## OFFICIAL NOTICE OF DECISION

**Project# 1010181**

RE: Project #1010181, PNM Richmond Switching Station  
Site Development Plan for Building Permit

RE: DRB Comment Responses – Project #1010181 – Richmond Switching Station

DESIGN VARIANCE FIGURE FOR PROPOSED SIDEWALK	DATE: May 22, 2015
DR: JLB	TR: OK
APP: TRF	SCALE: 1"=50'
REV. NO.	ACAD FILE: 980-5602
	SHEET 1 OF 1

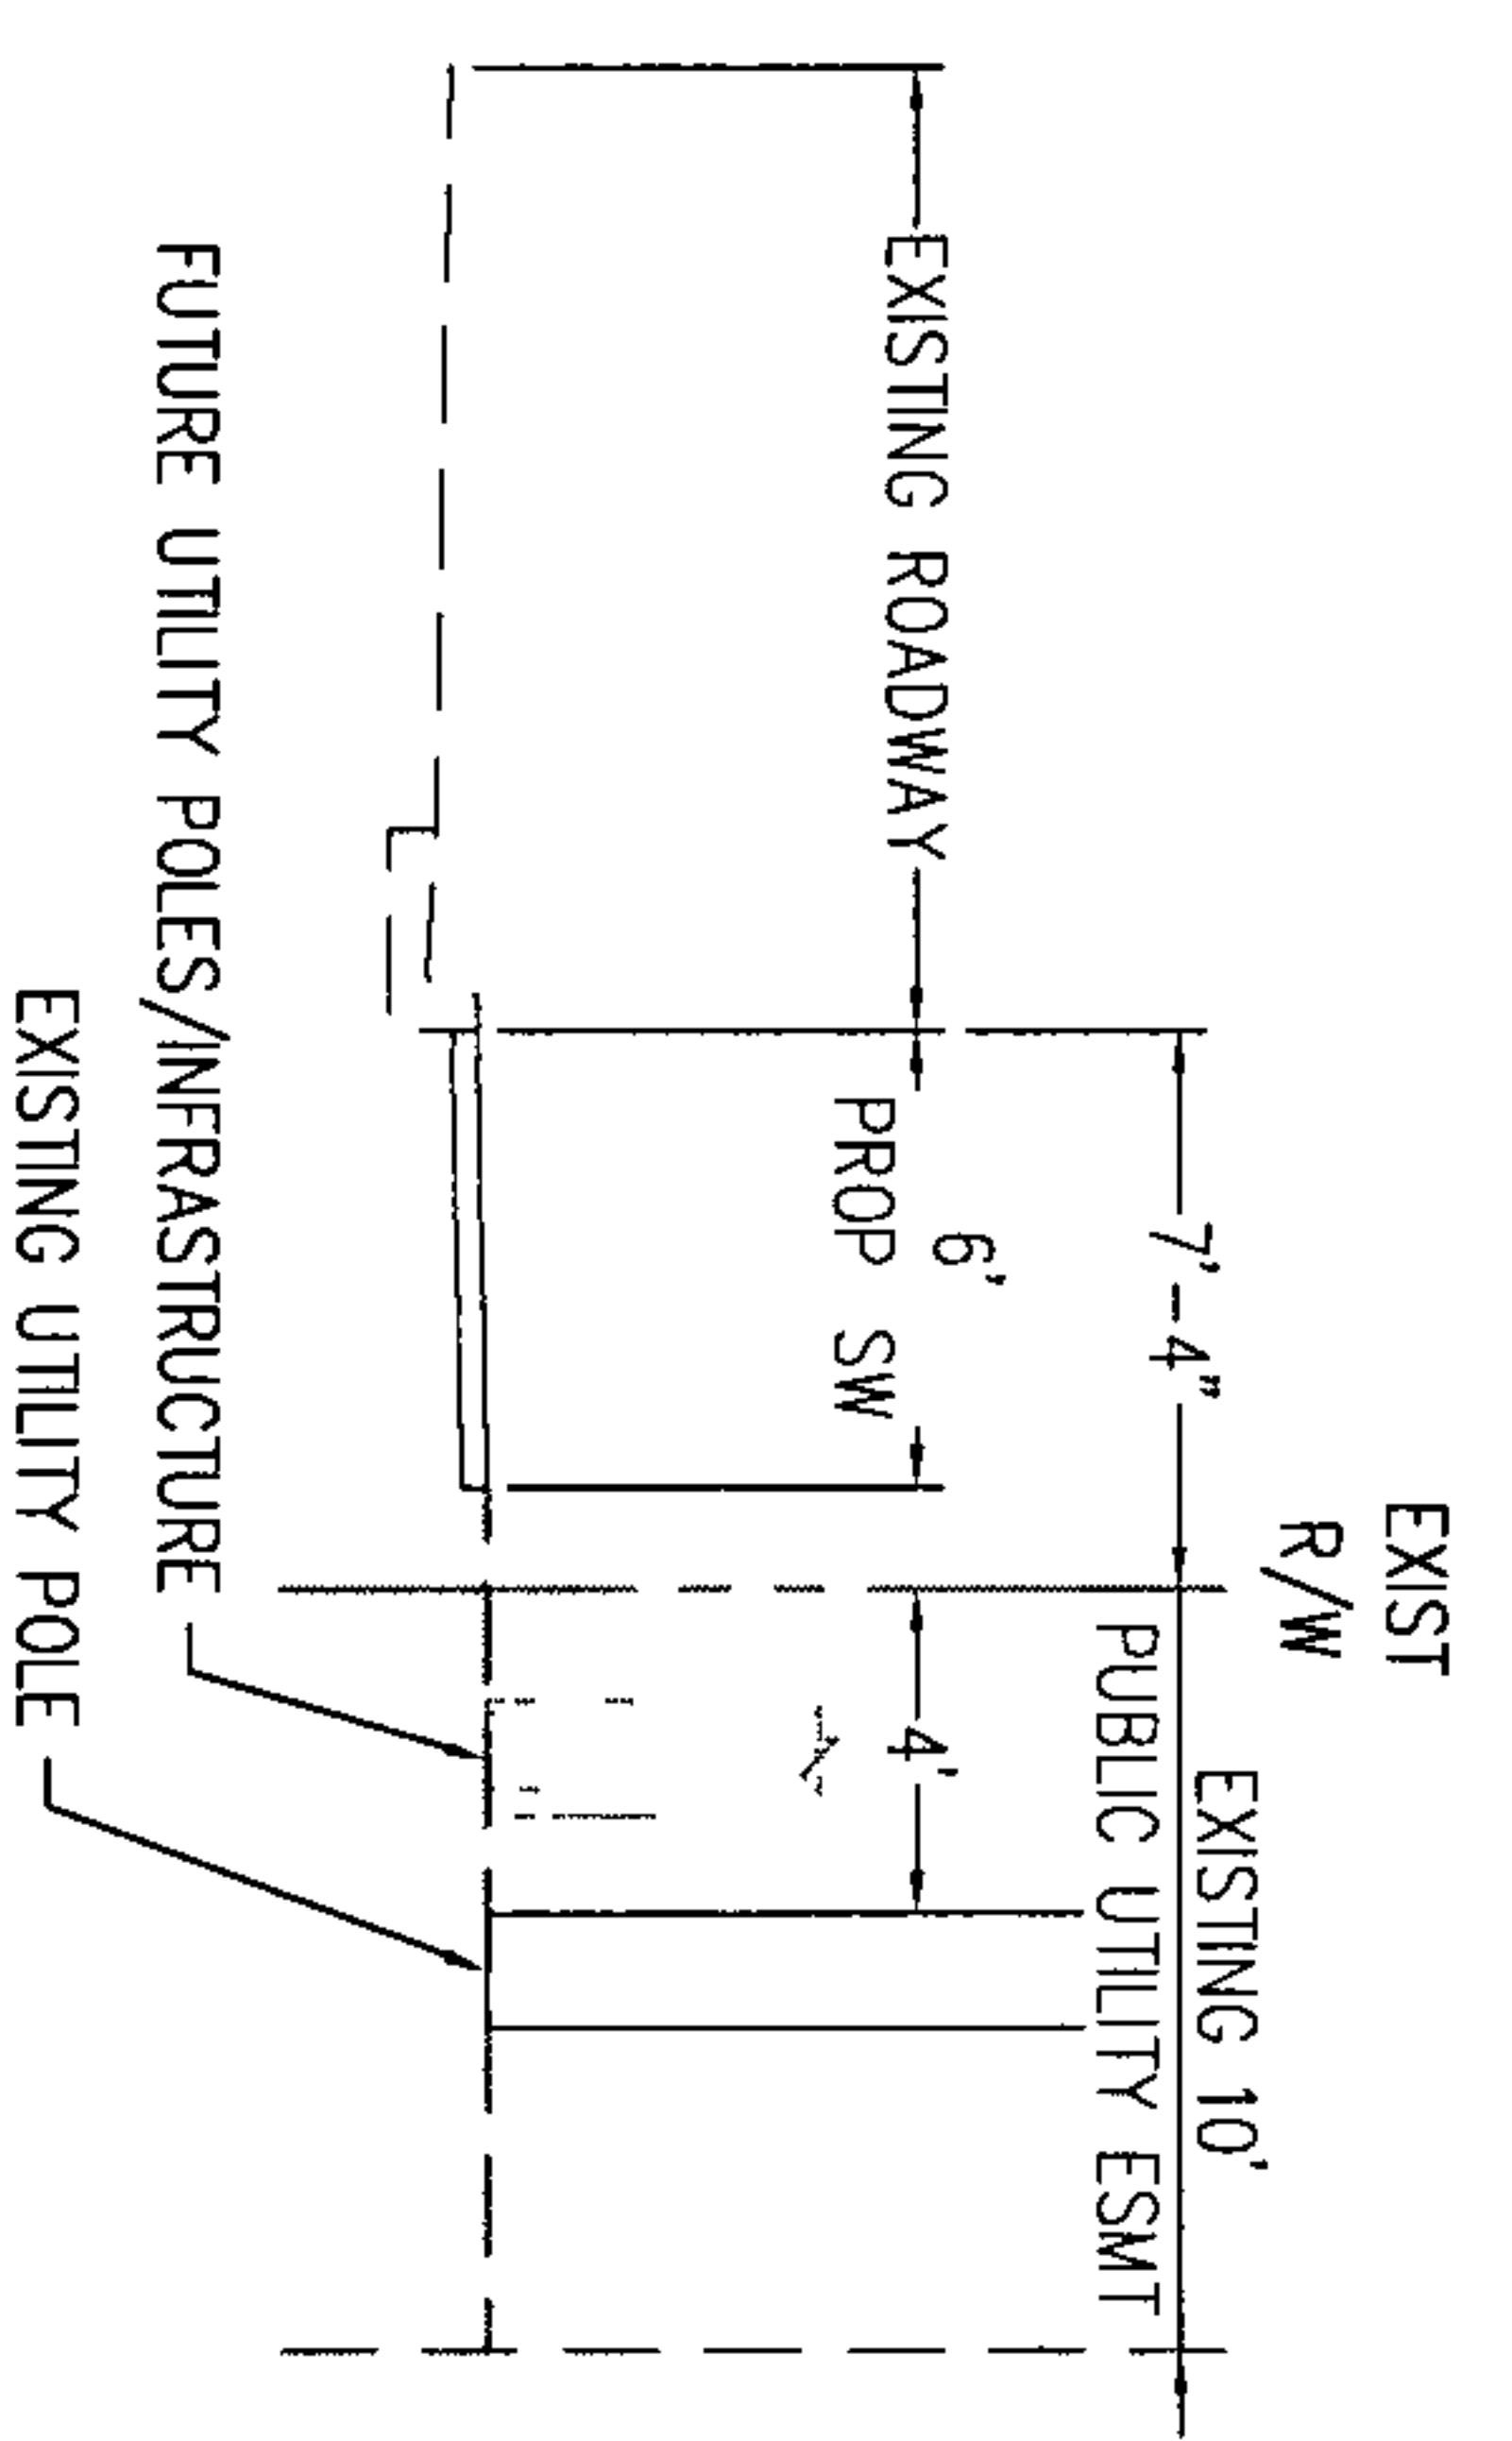
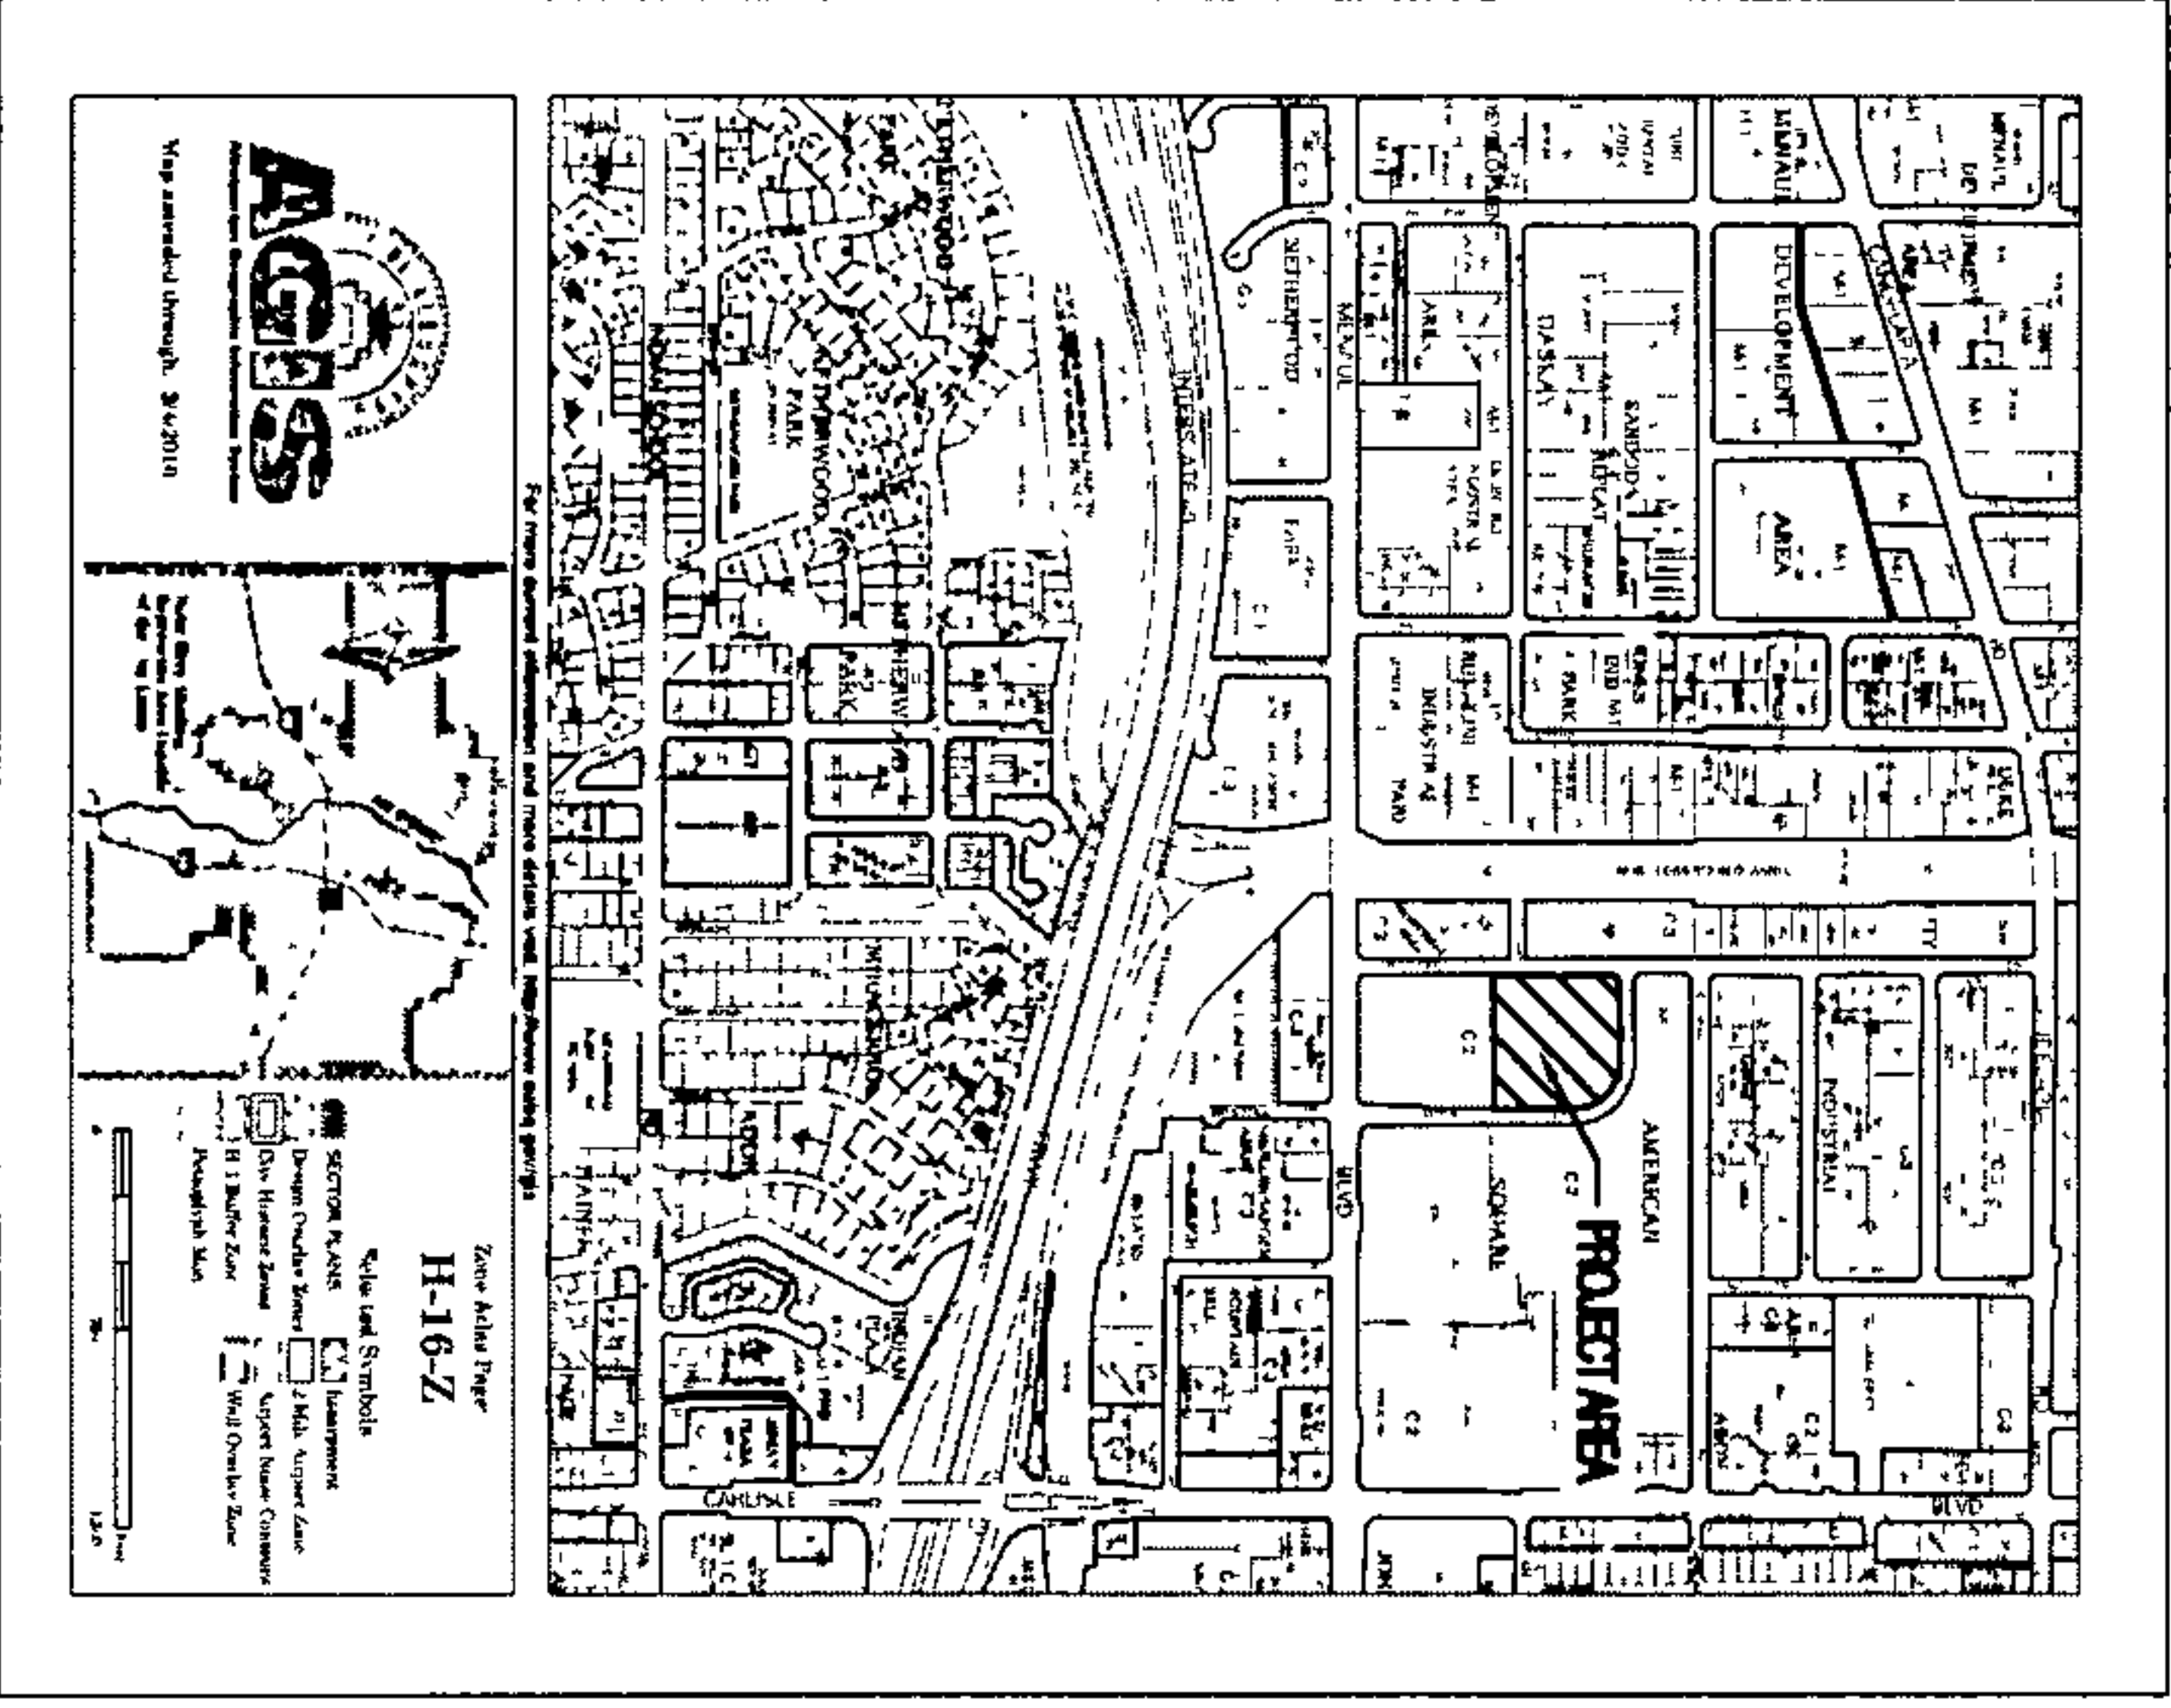
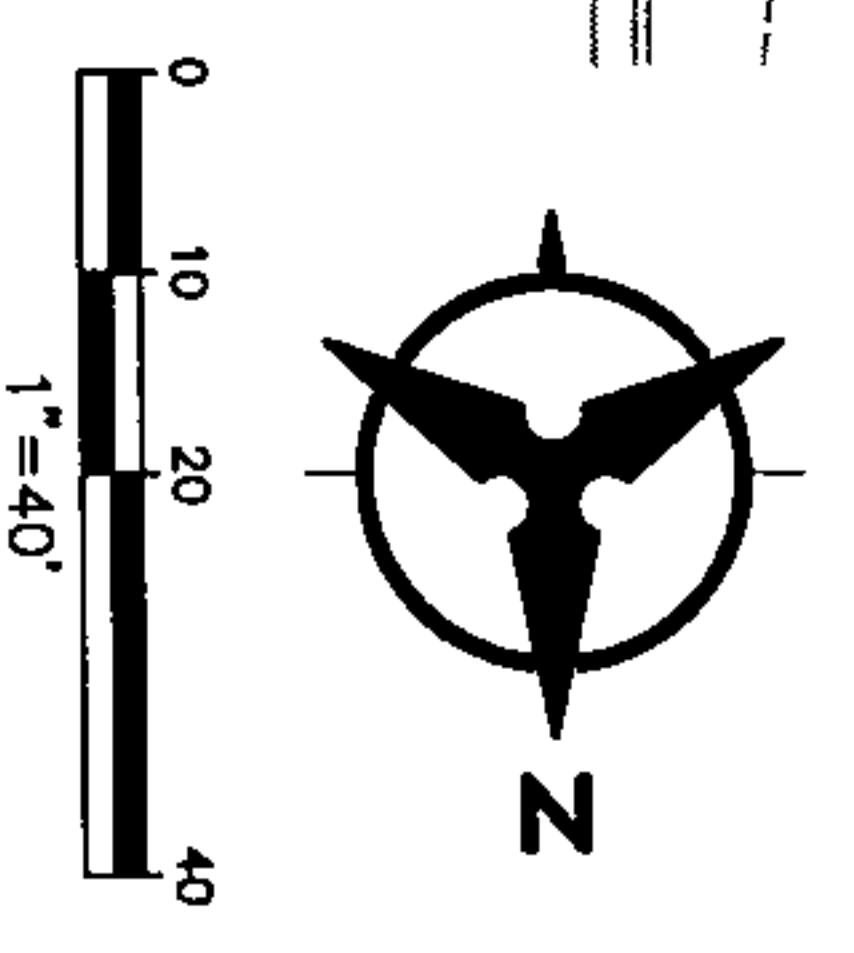
1. Provide an exhibit showing the location of the sidewalk and defining the distance from back of curb to the property line. Right-of-way dedication may be required.

- b. For the last sheet (exhibit), please correct the spelling of "proposed."

*The revised exhibit showing the location of the sidewalk and defining the distance from back of curb to the property line is enclosed. A sidewalk variance application has been submitted to the City of Albuquerque to address this comment.*

*The enclosed sheet has been revised to correct the spelling of the "proposed."*
